Research Reactor Facility

REFERENCE: Docket 50-186
University of Missouri Research Reactor
License No. R-103

SUBJECT: Responses to Request for Additional Information dated
January 25, 1990

Fig. 1

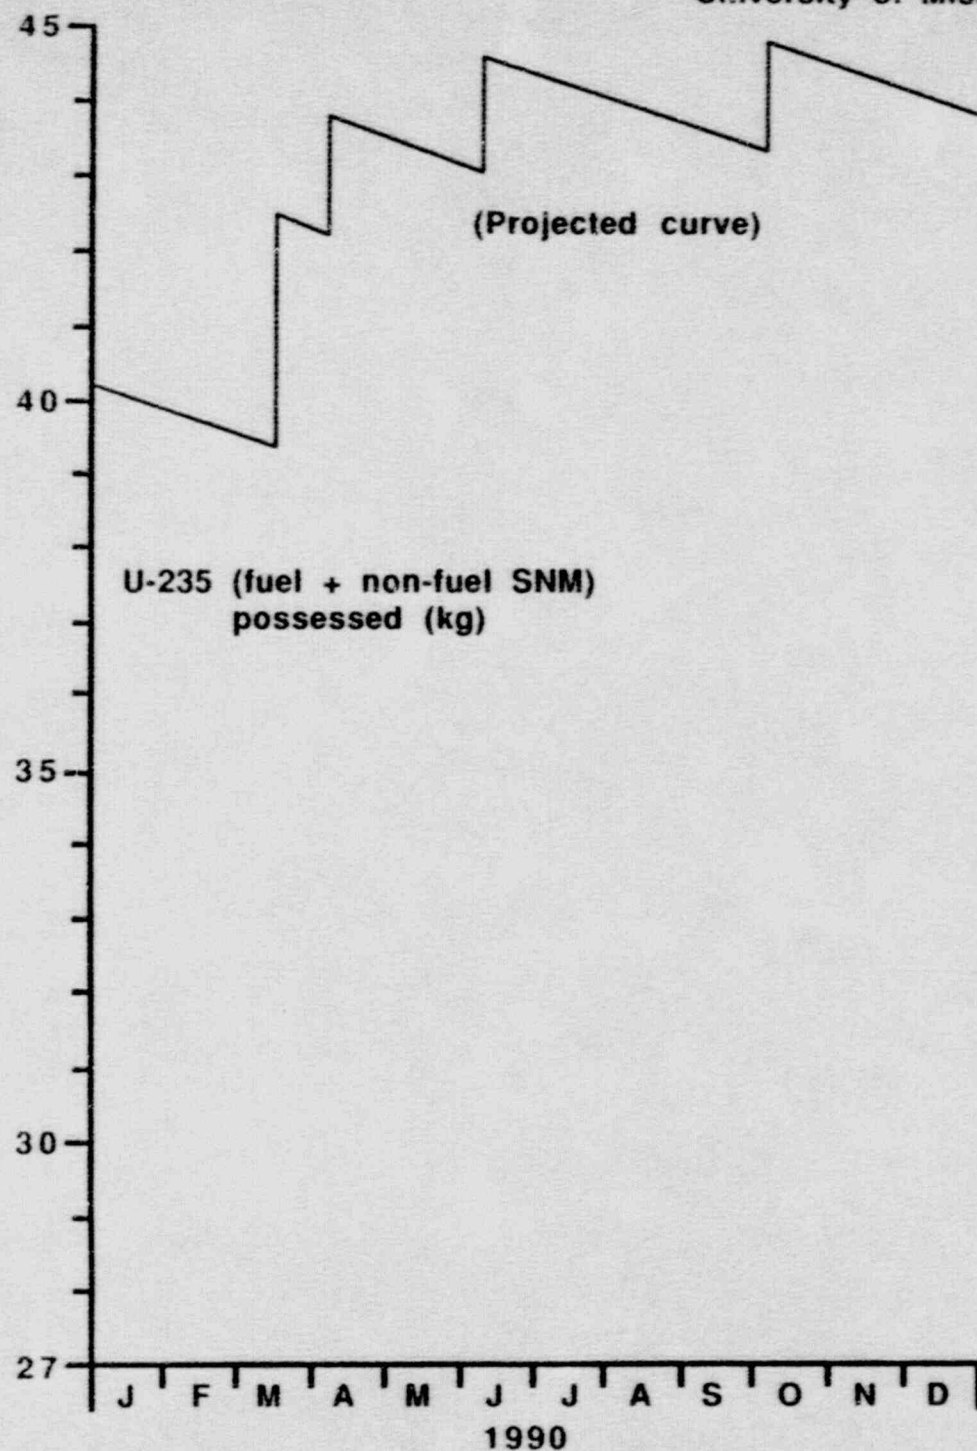
Assuming that the University of Missouri at Columbia Research Reactor (MURR) is unable to acquire a shipping cask, please estimate the date at which operation of the reactor would have to be terminated under the existing license possession limits.

It is difficult to define an absolute date at which operation of the reactor would have to be terminated with respect to existing license possession limits. Under the existing license possession limit for U-235 (45 kg), MURR has already begun modifying the schedule for receipt of new fuel. We will receive our scheduled four elements in March 1990, however planned shipments of four elements in April and June will be reduced to two elements. The planned August 1990 shipment must be cancelled altogether (See Figure 1).

By September 1, 1990, MURR will have received eight new elements in 1990, instead of the scheduled sixteen. At this time, insufficient fuel inventory will be available to consistently make cores with enough excess reactivity to run at 10 MW for 6.3 days/week as our programs and other national programs we support have required since September 1977.

Starting in September 1990, the fuel inventory with the existing license possession limit (45 kg) will dictate two refuelings each week and by early 1991, more than two refuelings each week. Obviously, the reactor could continue to operate on into mid and late 1991 if programs could be sustained with multiple refuelings per week. Unfortunately, they cannot.
